# TECHNICAL BULLETIN

**MODEL/DERIVATIVE:**  
Discovery series II (LT)

**Bulletin N°:** 0108  
**CDS. ref:** L8828bu  
**Issue:** 1  
**Date:** 23.10.02

**WATER INGRESS INTO REAR OF VEHICLE**

1

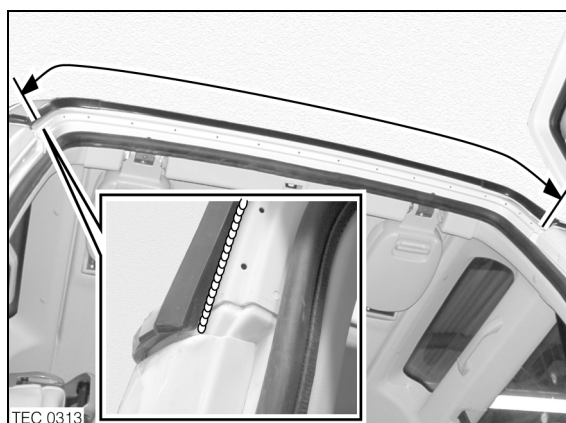
Sealing operation between the roof and the rear header outer joint inadvertently omitted.

Where a complaint of the above is confirmed, follow the rectification procedure below to apply sealant between the roof and rear header outer joint.

1. Open the taildoor.
2. Release 17 clips securing the taildoor aperture secondary seal to the body, remove seal.
3. Clean between the roof and the rear header outer joint (see illustration 1).
4. Apply a continuous bead of sealant between the roof and the rear header outer joint (inset in illustration 1).
5. Wipe off any excess sealant.
6. Fit and secure the taildoor aperture secondary seal to the body.
7. Close the taildoor.
